AMPEX

MAGNETIC RECORDERS

SERVICE BULLETIN

DATE: 20 March 1953
MODEL: 300
BULLETIN NO: 2
PAGE NO: 1

ADJUSTMENT OF AC SOLENOIDS ON RECORDERS BELOW SER. NO. 500

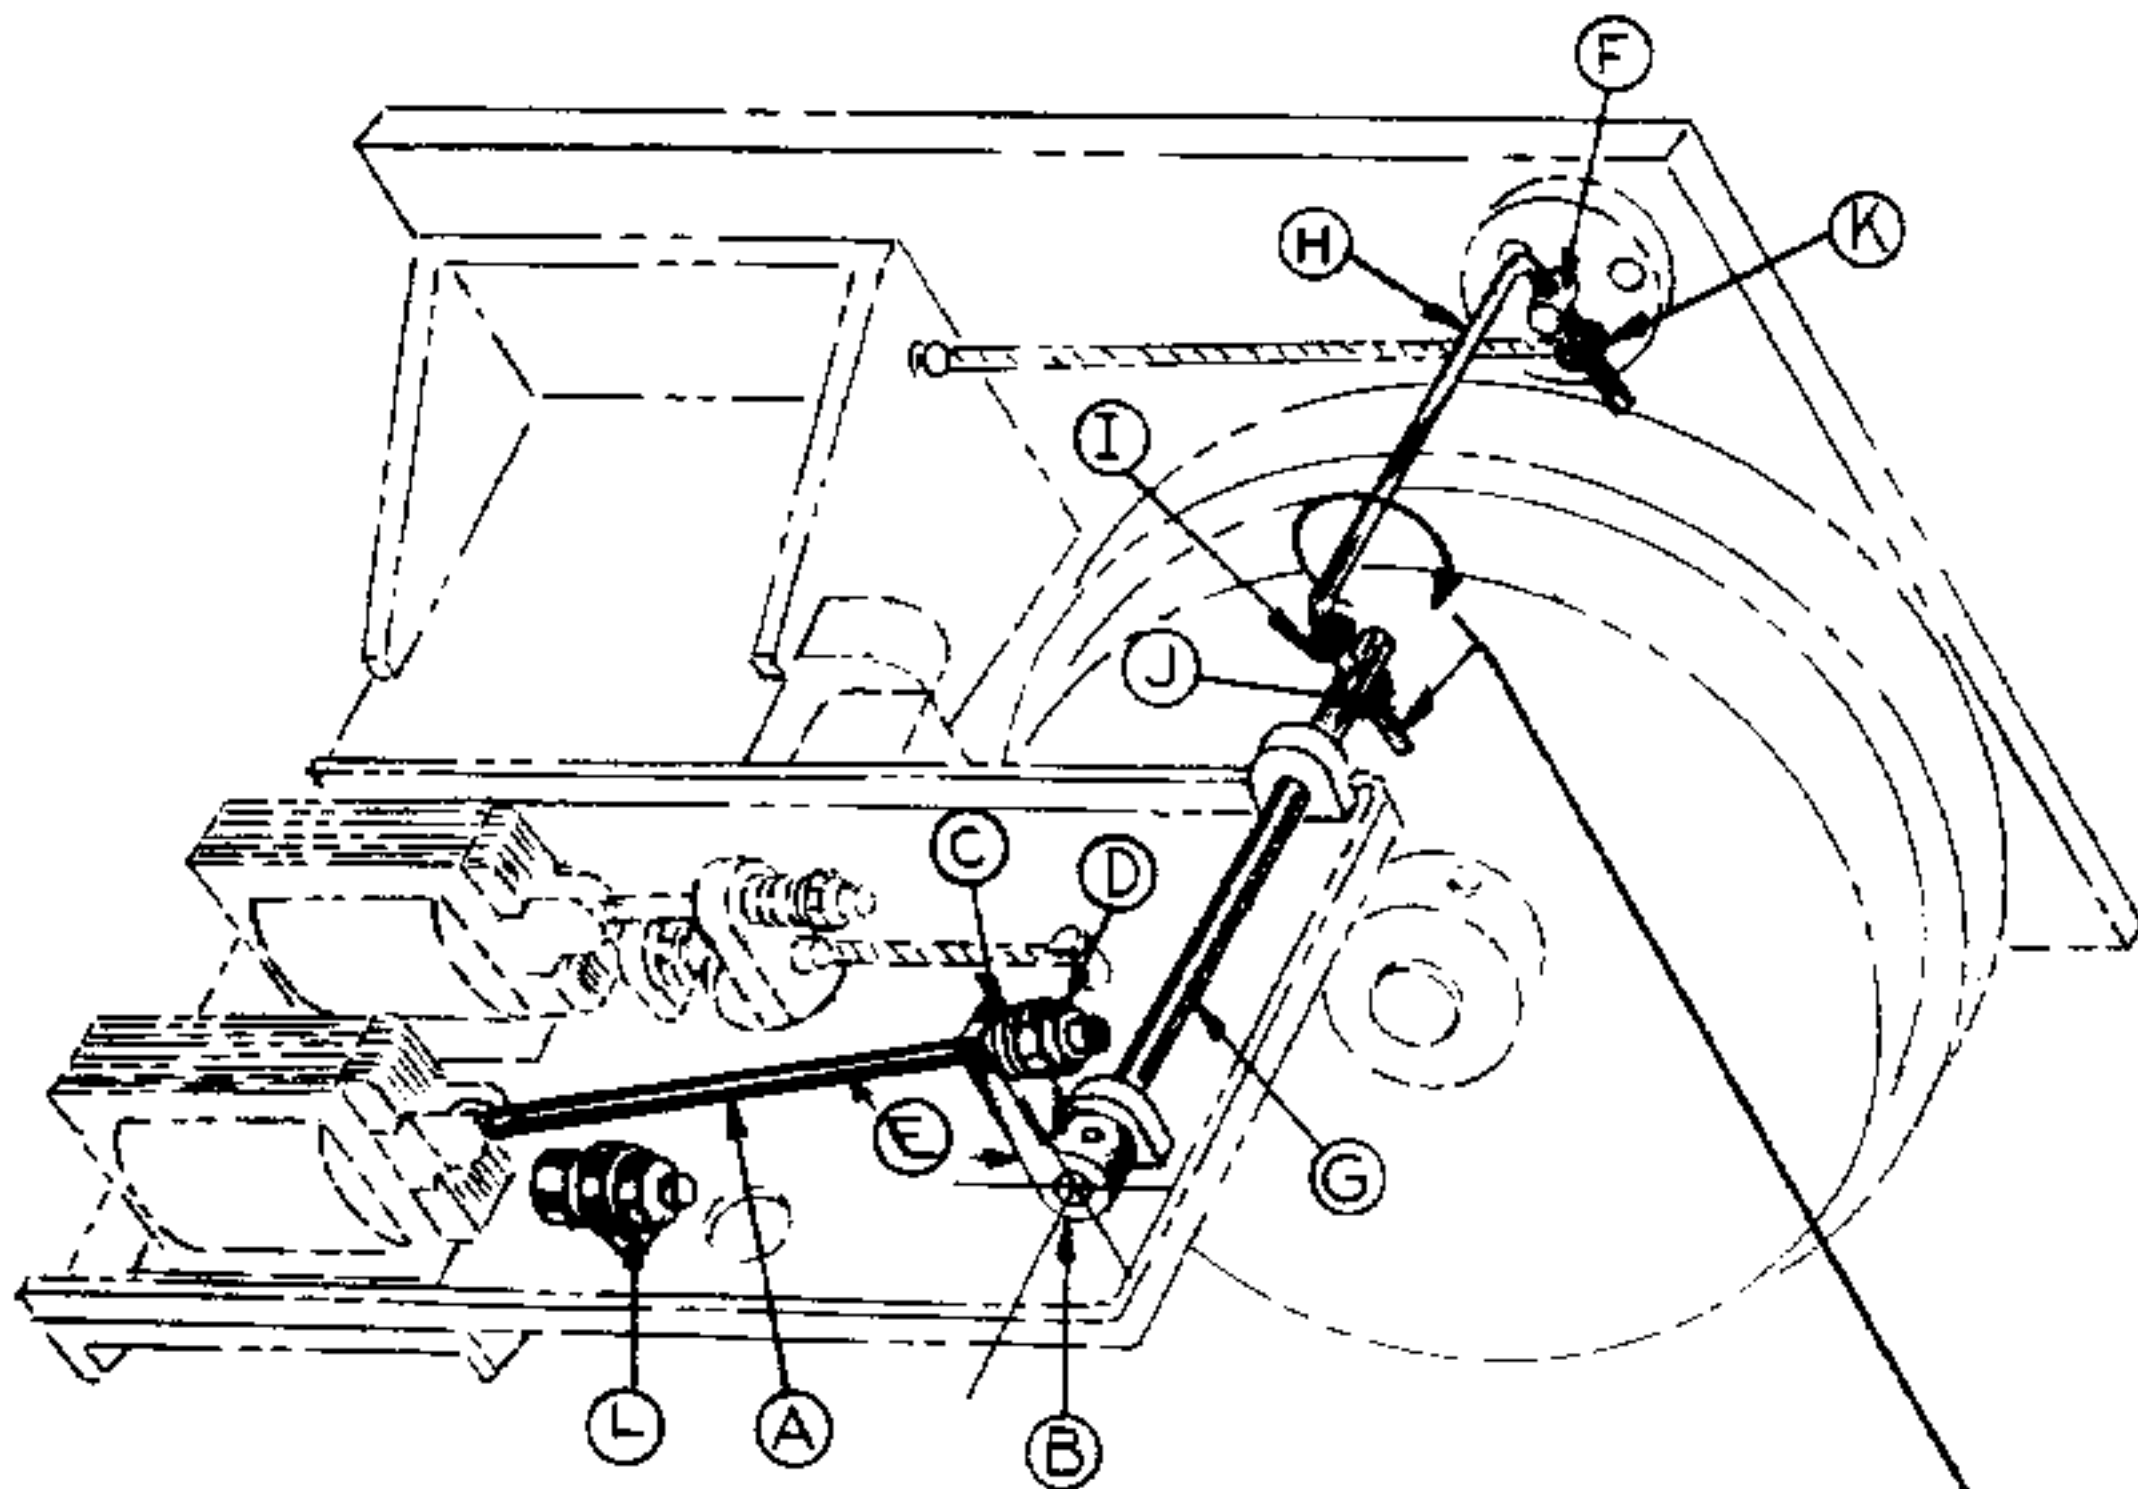
The importance of maintaining the above angle E below 90° was only recently discovered, and it is possible that some machines have been shipped in which this angle might be too great. While no machines have been shipped with noisy solenoids, it is possible that if the above adjustment is not proper the solenoids may become noisy in use. Should this be the case, the adjustment can be corrected as follows:

It will be noted that the capstan idler arm shaft F is connected to the operating shaft G below through a U-shaped torque link H. If the bottom (or shorter) arm of this link H is bent in a clockwise direction (when looking at the link from the bottom or short arm end), this will effectively reduce the angle E. In order to bend this arm, it is necessary to remove link H and hold it in a vice. The link can be removed by forcing off the spring-lock washers which position the lower arm (I and J) and which attach the return spring at the top (K). The proper value for the angle E is approximately 85° , or when the arm H is perpendicular to the plane of the solenoid base plate.

TO REDUCE ANGLE E, BEND
THIS ARM CLOCKWISE WITH
RESPECT TO UPPER ARM. RESET
ADJUSTING NUT D & L.

ANGLE E MUST BE LESS THAN 90° WHEN
CAPSTAN SOLENOID IS SEATED.

If the angle E is changed, it will be necessary to re-set the capstan idler adjustment D. This adjustment is set so that when the capstan idler just touches the capstan, the solenoid is $1/8$ inch shy of seating. A simple way of making this setting is to place a piece of material $1/8$ inch thick between the solenoid armature and body and clamp the armature down on it. Then tighten the nut D until the capstan idler just touches the capstan.

It may also be necessary to reset the capstan idler solenoid Stop L. This stop should be set so that at no time during fast winding does the tape touch the capstan idler.

PLUGGING OF CAPSTAN OIL
HOLE ON RACK MOUNTED
UNITS

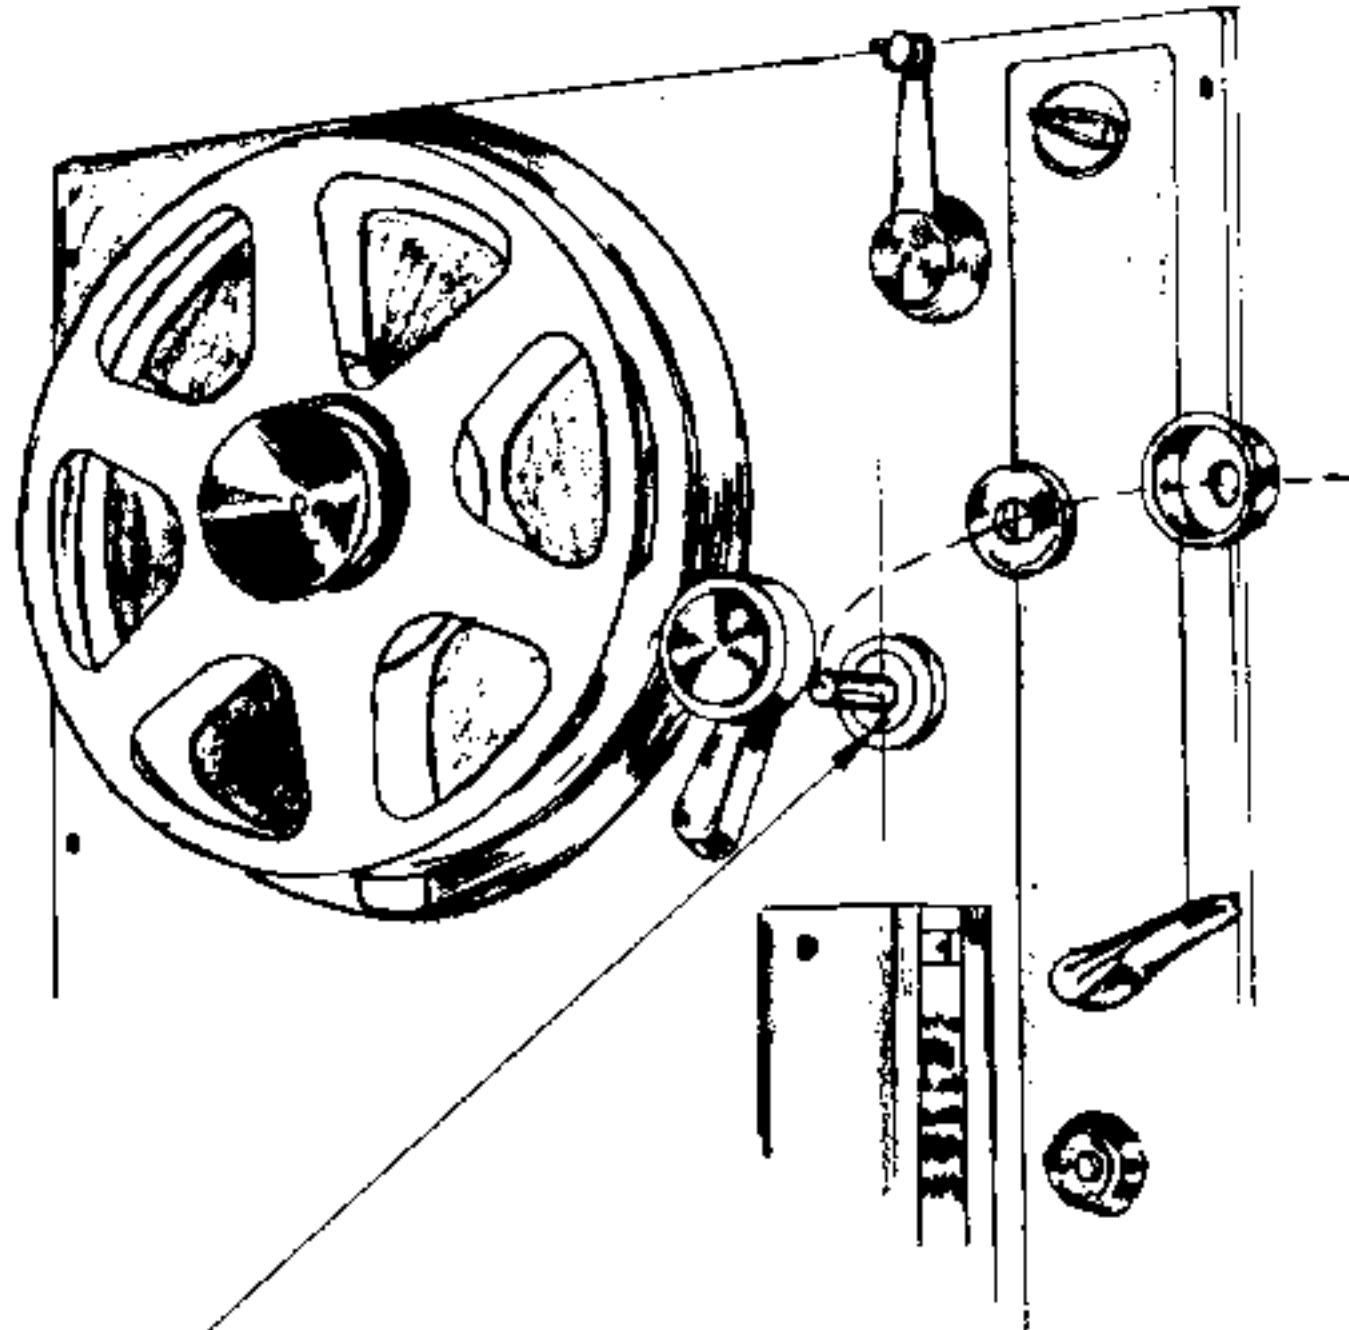
1. Capstan Oil Leakage. There is a tendency for oil to climb out of the capstan bearing housing during the first few weeks of operation. The capstan bearing has been thoroughly impregnated with oil so as to drive out any air inclusions, as the presence of air would tend to force oil out of the bearing housing when it becomes warm. The excess oil present climbs up the capstan when the machine is operated. Ordinarily, this oil is caught by the felt washer on top of the bearing housing. (The neoprene washer shown in fig. 2 of the instruction book was eliminated in production because it produced flutter.) If this washer becomes saturated with oil, which usually happens, then it will no longer behave as an effective seal. Therefore after the first week or so of operation, when most of the excess oil has had a chance to work out, the felt washer should be removed and washed out in carbon tetrachloride. Simply remove the capstan dust cap (see fig. 2, instruction book) to remove the felt washer. If this washer is kept reasonably dry, then no trouble should be experienced with oil creeping up the capstan.

REMOVE CAPSTAN DUST COVER
& FELT WASHER AS SHOWN
POSITION CAPSTAN ASSEM.
SO THAT CENTER LINE BETWEEN
BOTH HOLES IS VERTICAL WITH
LARGE C'SK HOLE ON THE
BOTTOM AS SHOWN. IF CAPSTAN
SHOULD NEED POSITIONING SEE
SVC. BULL. *14
TAP 6-32 N.C. IN LARGE C'SK HOLE
INSERT 6-32 X 1/4 LG. FLAT HD. MACHINE
SCREW.

DRIVE MOTOR REPLACEMENT

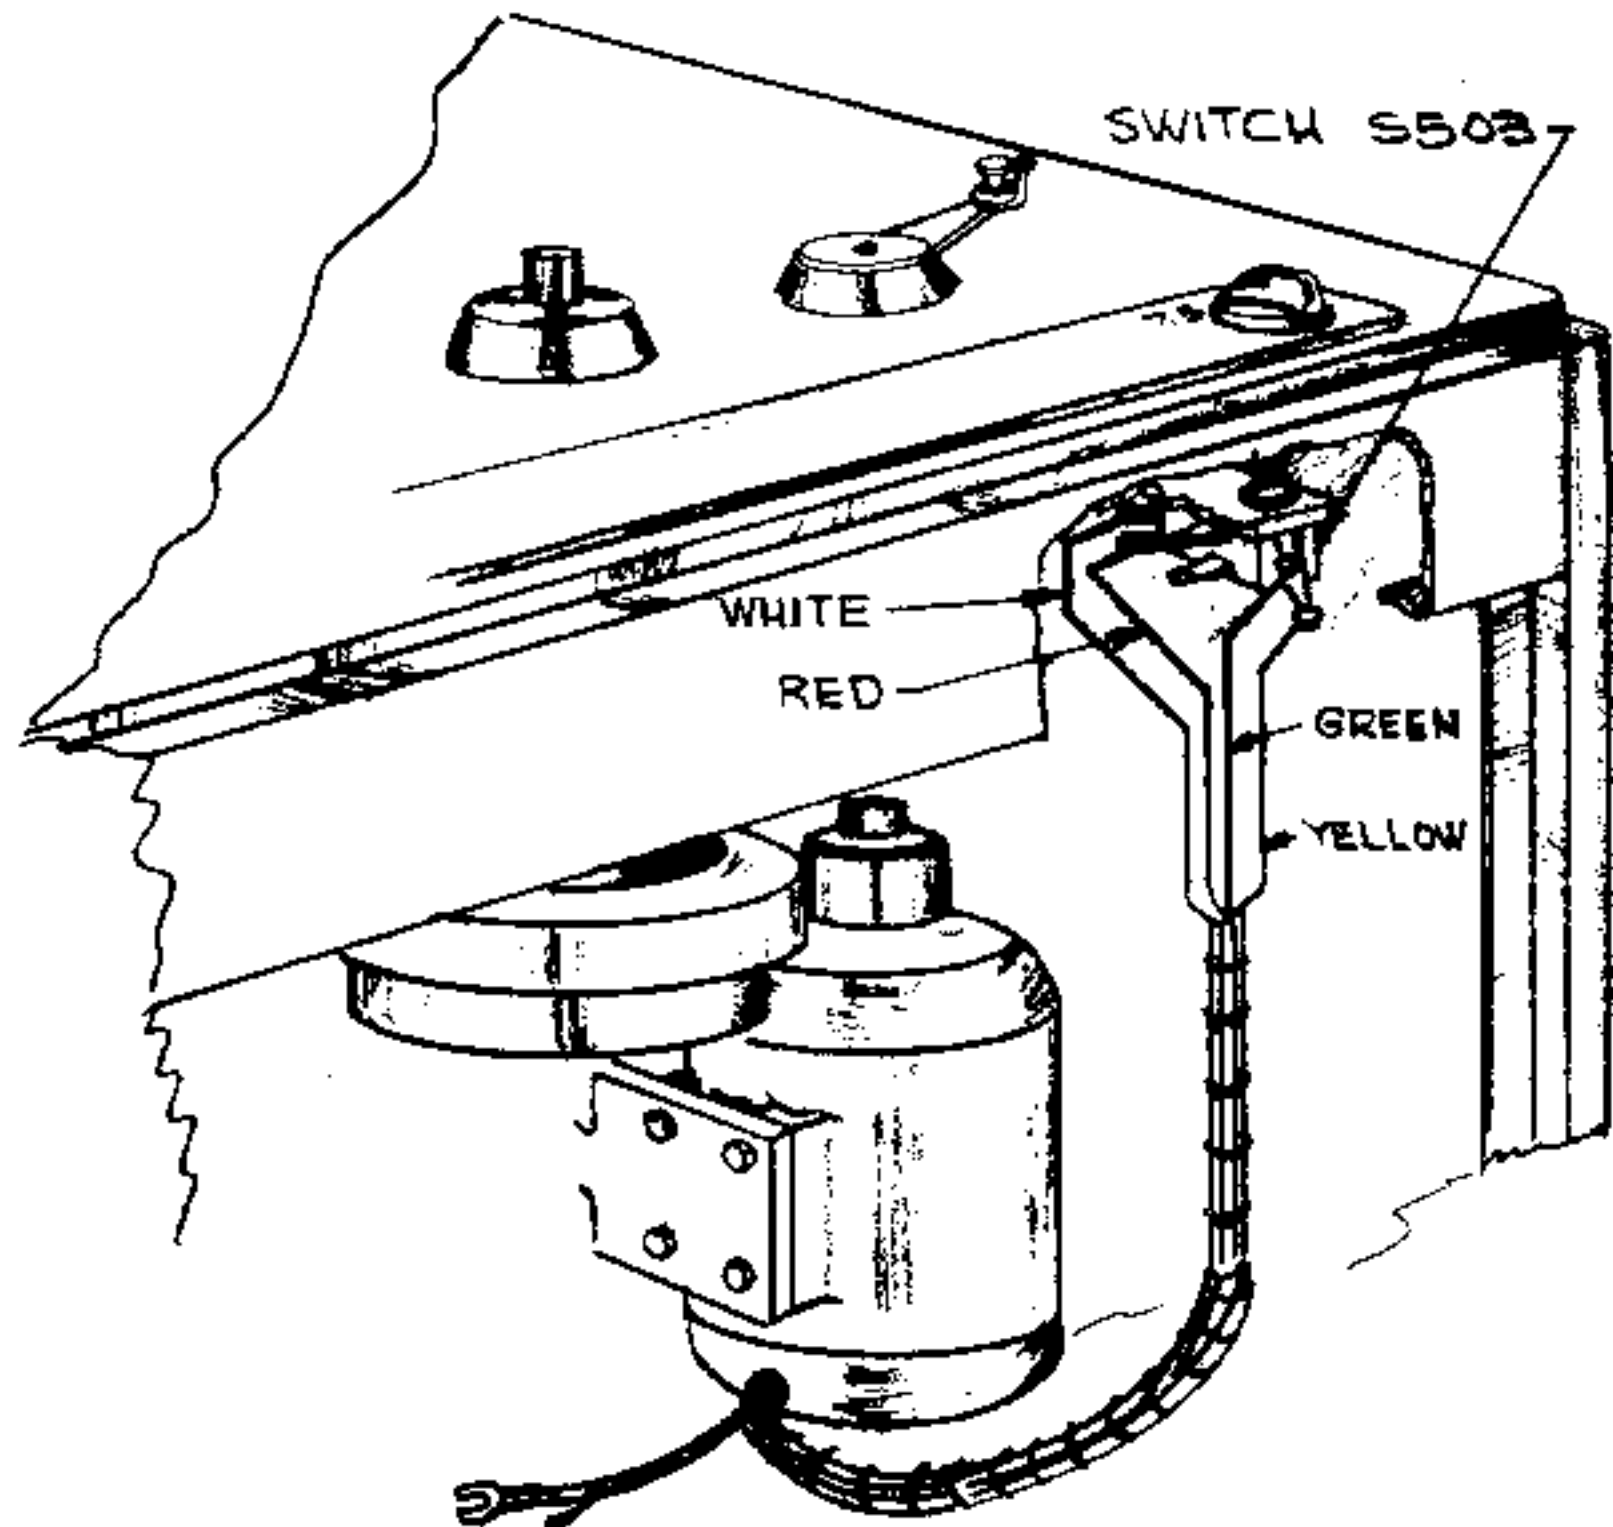
To install the new motor, first remove the old unit by unsoldering the leads from the switch S-502 and removing the black lead from Terminal Strip. Remove the four mounting screws which fasten the motor to the hinged bracket.

Install the new motor and connect as shown in the accompanying illustration, being careful to follow the color code of the leads. Before tightening the four screws in the motor base, swing the motor pulley into contact with the rubber tire and check for alignment. (Motor and Capstan shafts should be approximately parallel) A slight amount of adjustment is available due to the clearance of the holes in the hinged bracket supporting the motor.

BLACK WIRE TO NO. 1
TERMINAL ON DRIVE
ASSEM. TERMINAL
STRIP TS 501
